FINAL DRAINAGE REPORT for

Legacy Church
10460 W Hwy 24,
Green Mountain Falls, CO

PCD File No. PPR1933

Prepared: July 19, 2019
Resubmitted: September 17, 2019

DETENTION BASIN STAGE-STORAGE TABLE BUILDER

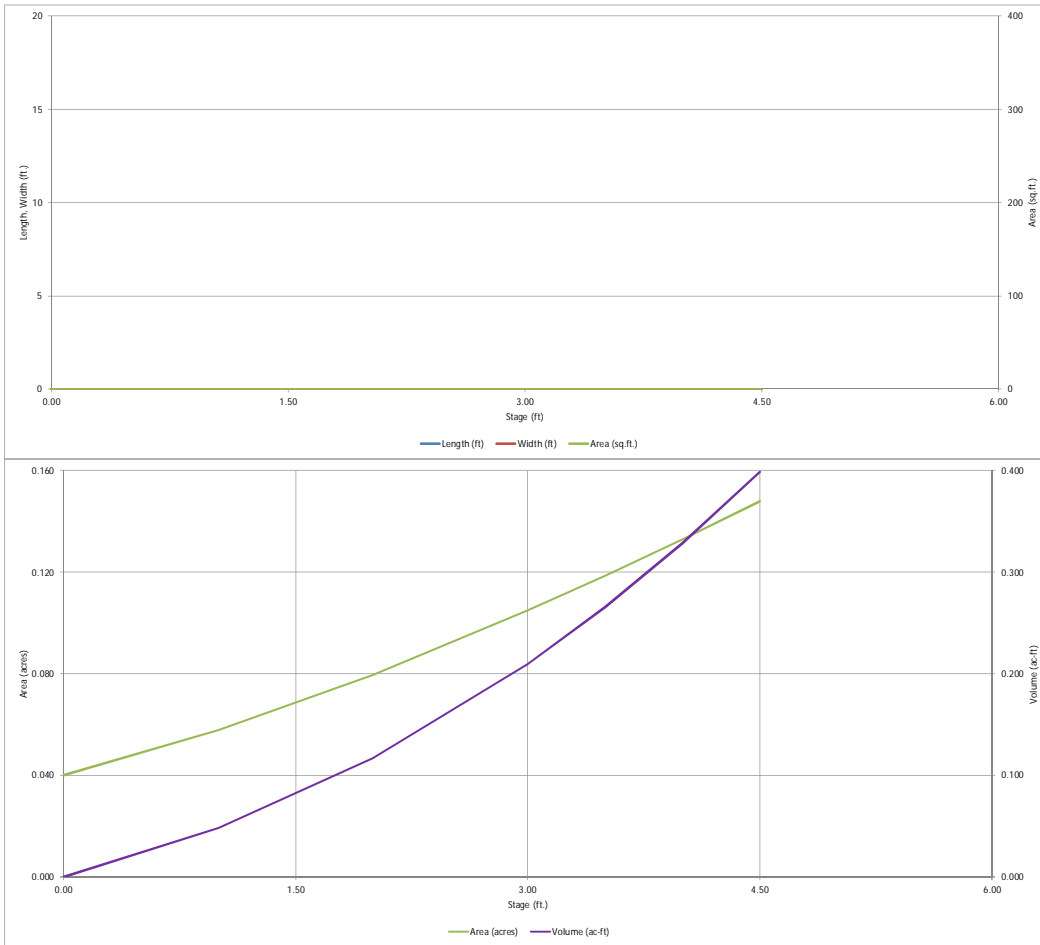
Pond construction plans and details have not been provided for either pond. Further review of the detention basin calculations will be done upon submittal of the construction plans which may generate additional comments.

DETENTION BASIN STAGE-STORAGE TABLE BUILDER

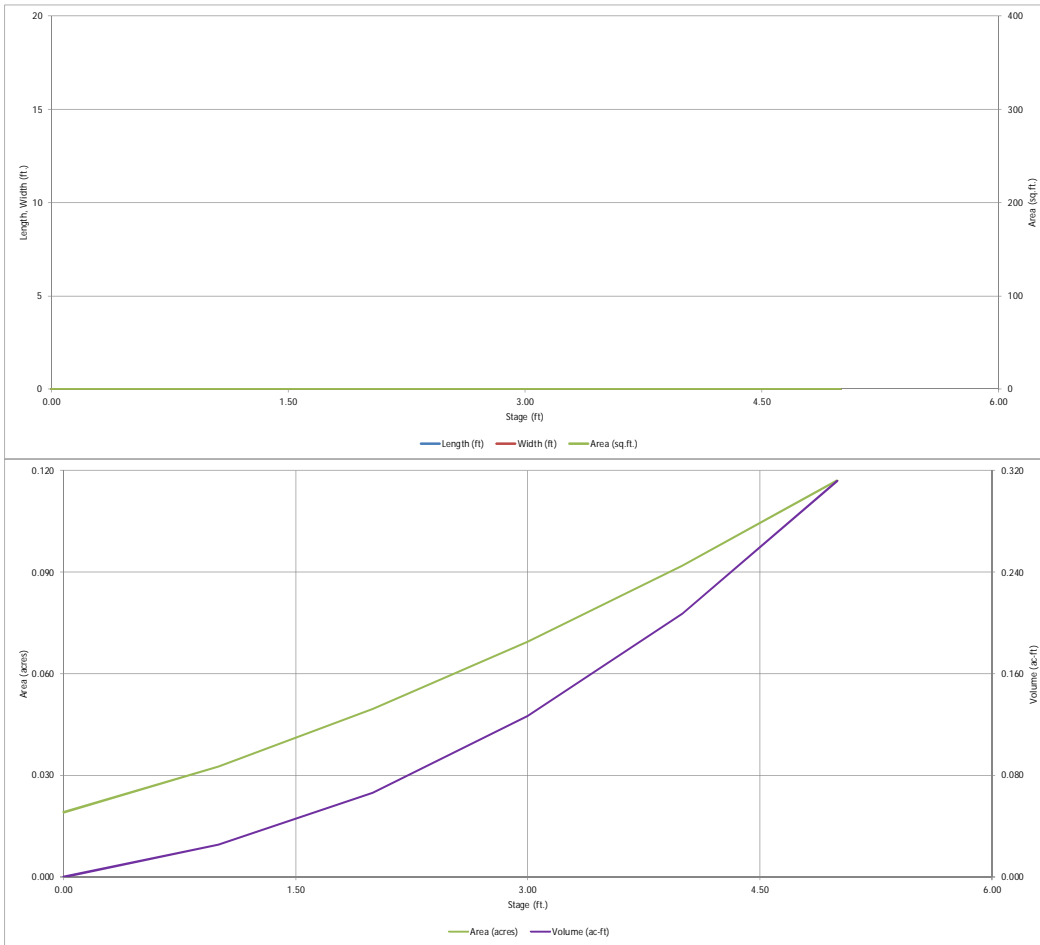
Pond construction plans and details have not been provided for either pond. Further review of the detention basin calculations will be done upon submittal of the construction plans which may generate additional comments.

EXISTING AND PROPOSED DRAINAGE MAP

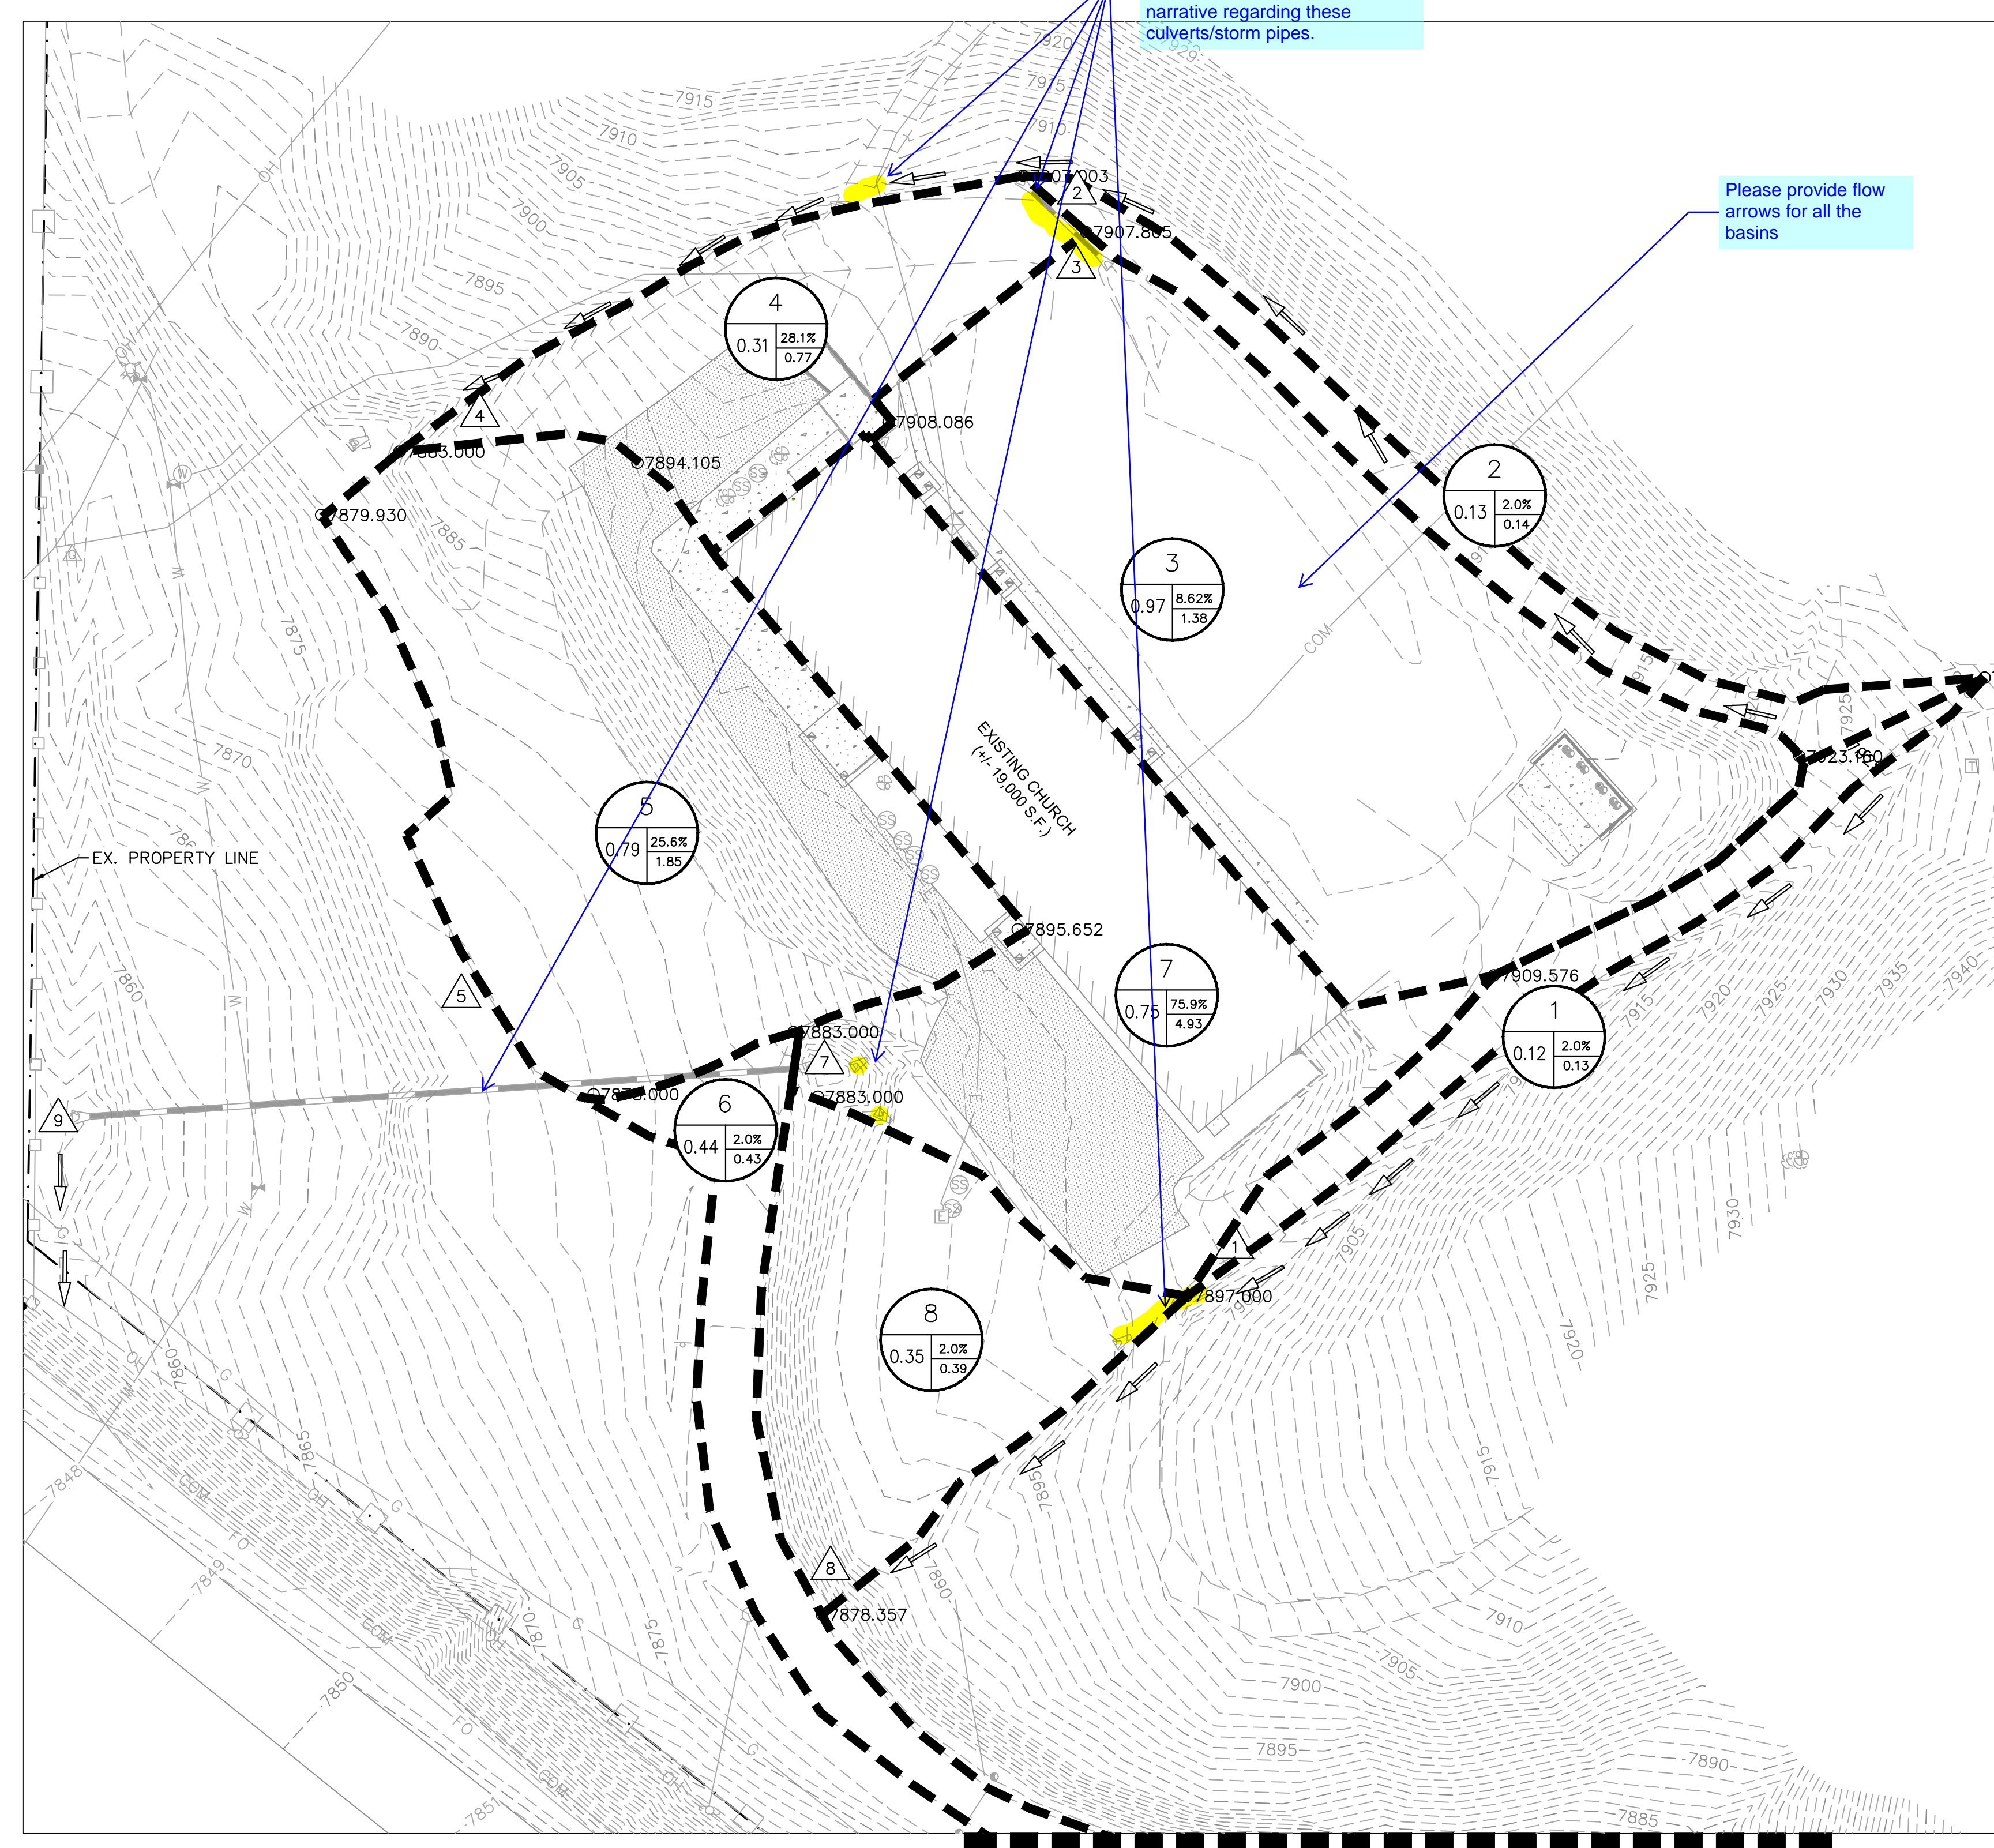
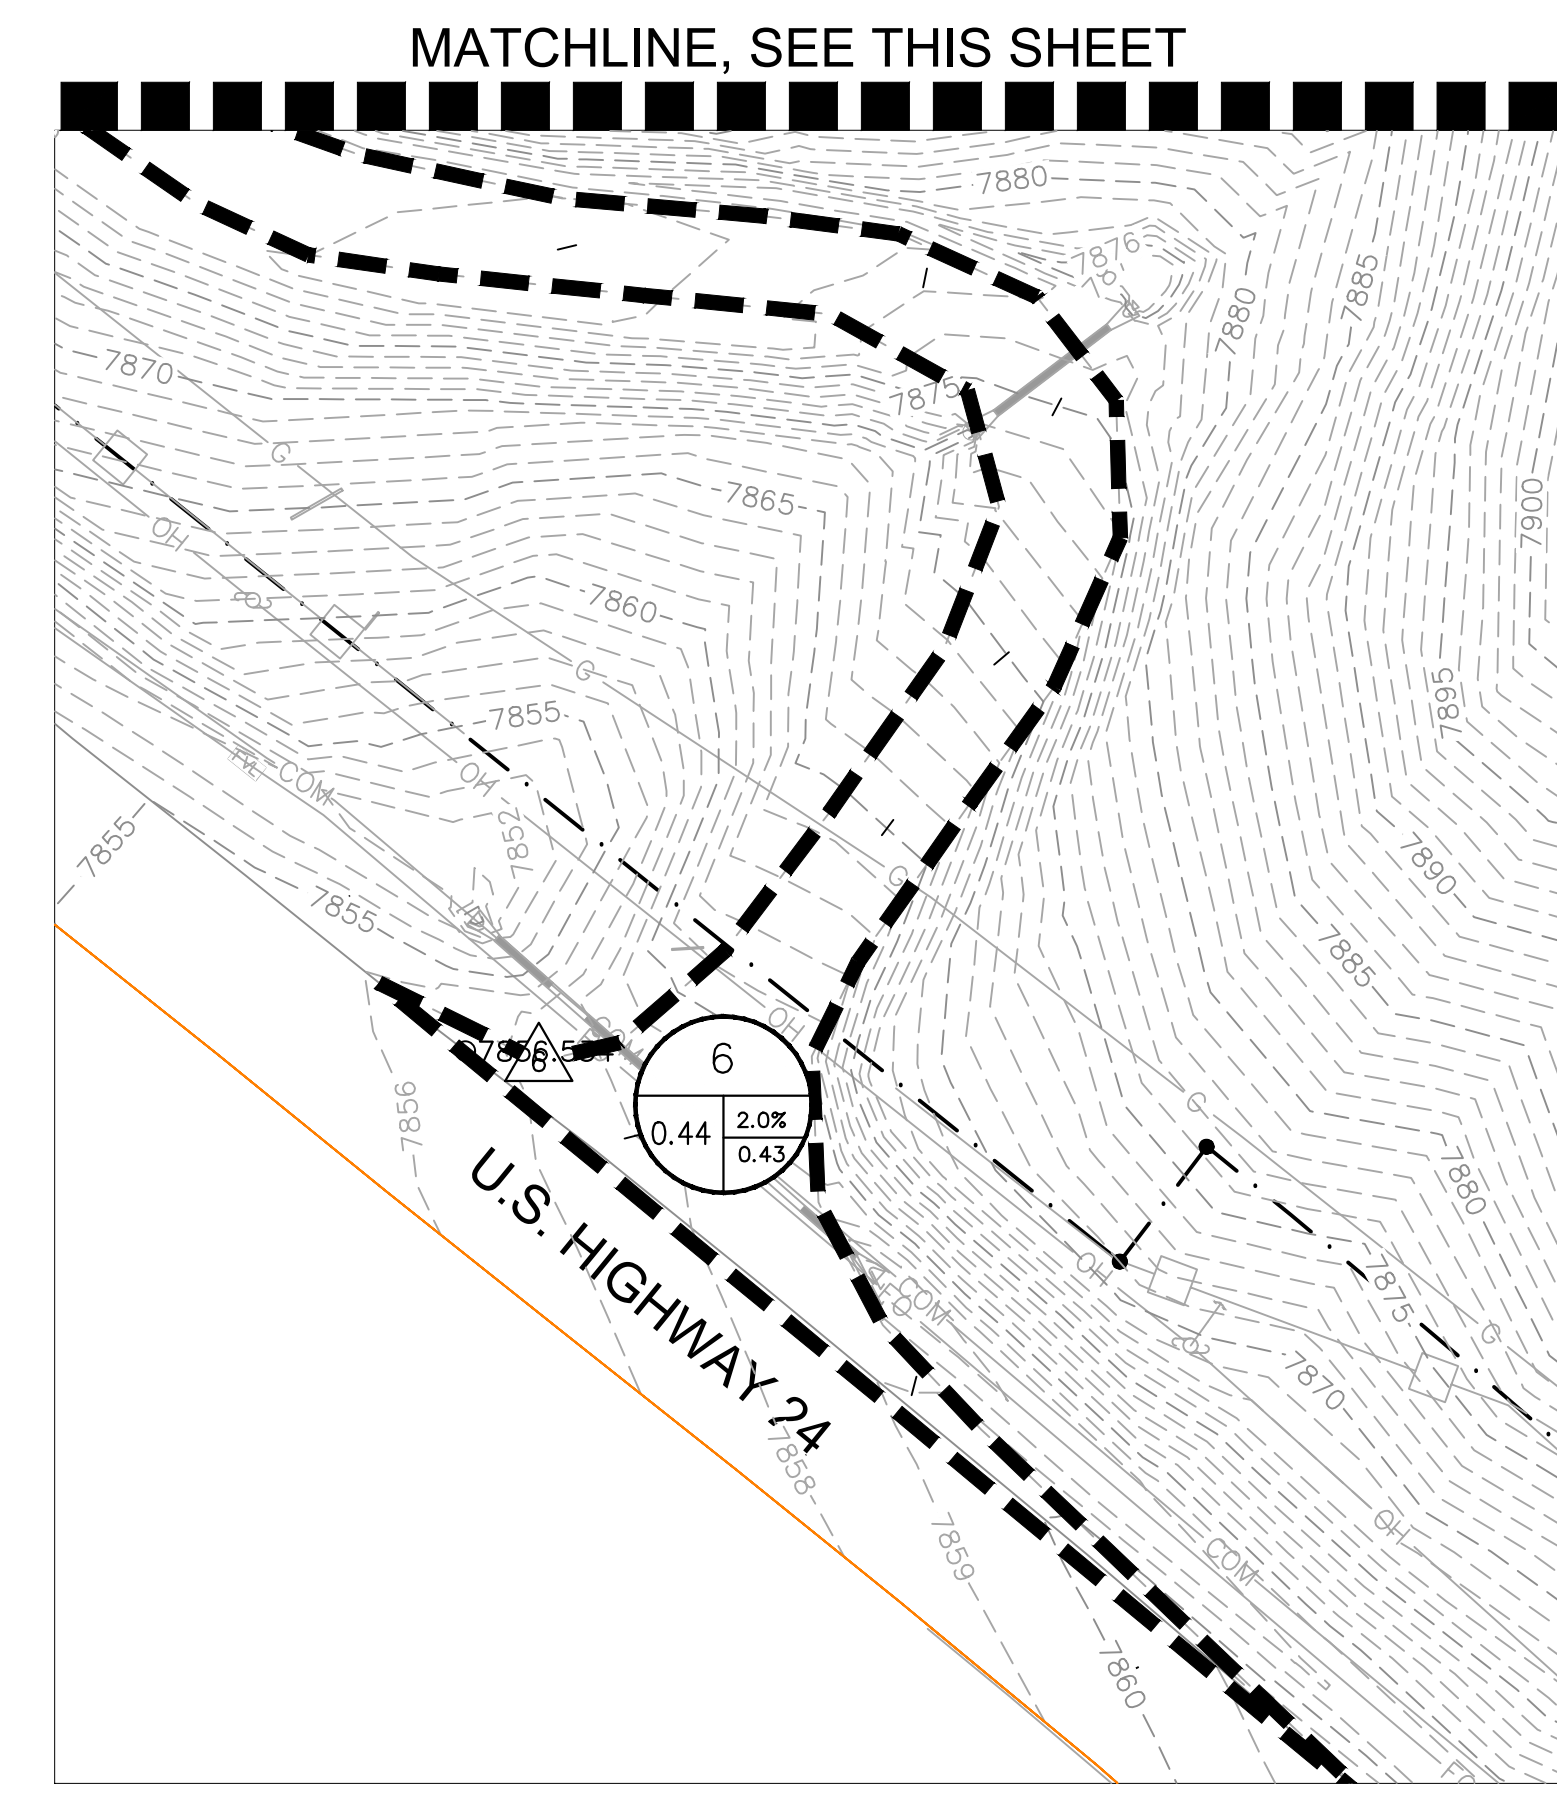
Please show and label all existing culverts/storm pipes, providing their size and type. Include discussion in the narrative regarding these culverts/storm pipes.

Please provide flow arrows for all the basins
